Thor Motor Coach Recall Repair Instructions

Recall #	20V-419 2020-332		
Description/Title:	Battery Cable Routing		
Affected Product Line(s):	Certain model year 2021 Daybreak, Four Winds, Quantum, Chateau, and Freedom Elite motorhomes built on the 2020 Ford E-Series chassis		
Service Campaign # :	RC000197	Released Date:	09/04/2020
Repair Code:	Inspect Only: TMCRC80492Y Inspect with Repair: TMCRC80492V	Document Date:	09/04/2020
Time Allowed:	Inspect Only: 0.2 Inspect with Repair: 0.4	Document Revision:	A

(Additional examples of correct and incorrect routing)

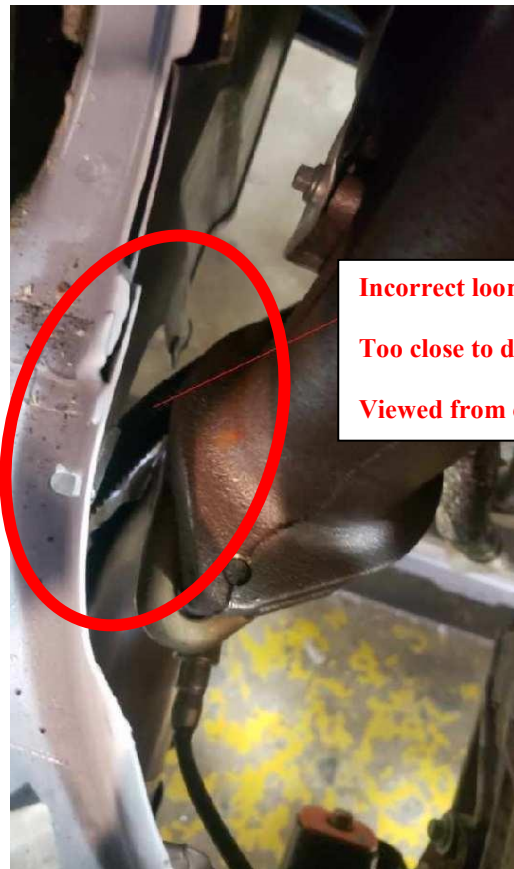
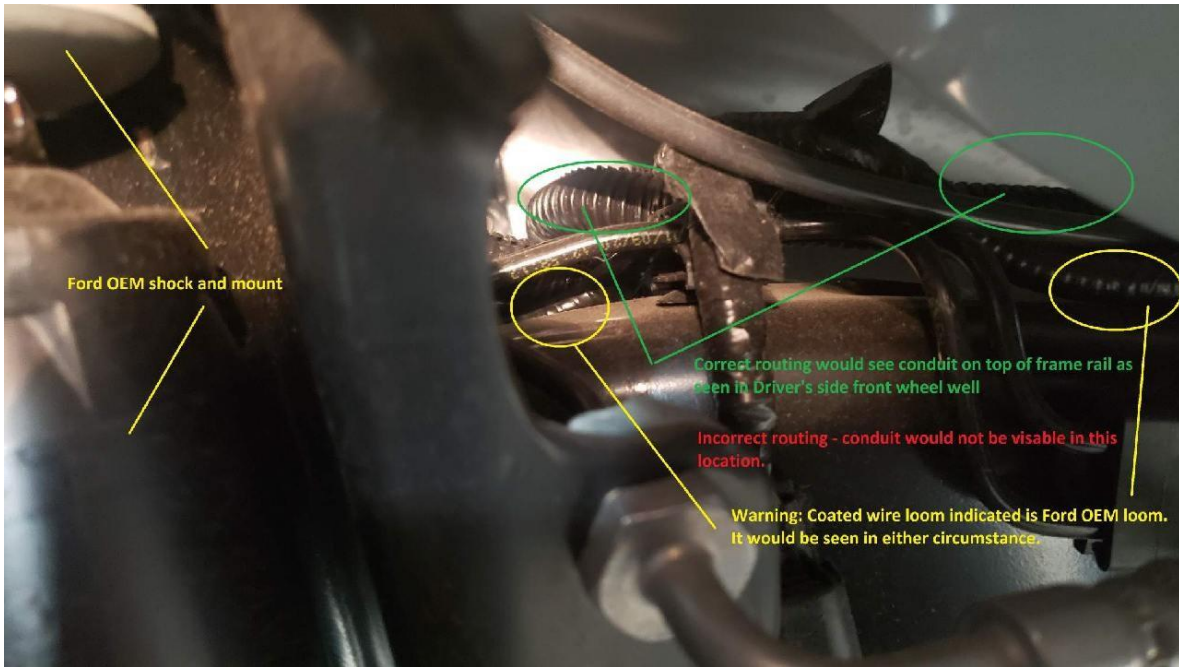
Incorrect loom location

Too close to driver side manifold

Viewed from cab with engine cover removed

4. If needing to secure cable, use UV rated zip ties to properly secure cable to frame rail and away from manifold.
5. If cable will need to be re-routed:
 - a. Lift entry step lid to access house batteries.
 - b. Remove positive cable from batteries.
 - c. Remove ½ in. nut off battery solenoid to remove cable.
 - d. Re-route as needed along frame rail to ensure cable is away from heat shield and conduit is visible on top of frame rail from driver's side front wheel well. Be sure to properly secure once re-routed.
 - e. Re-install cable to solenoid.
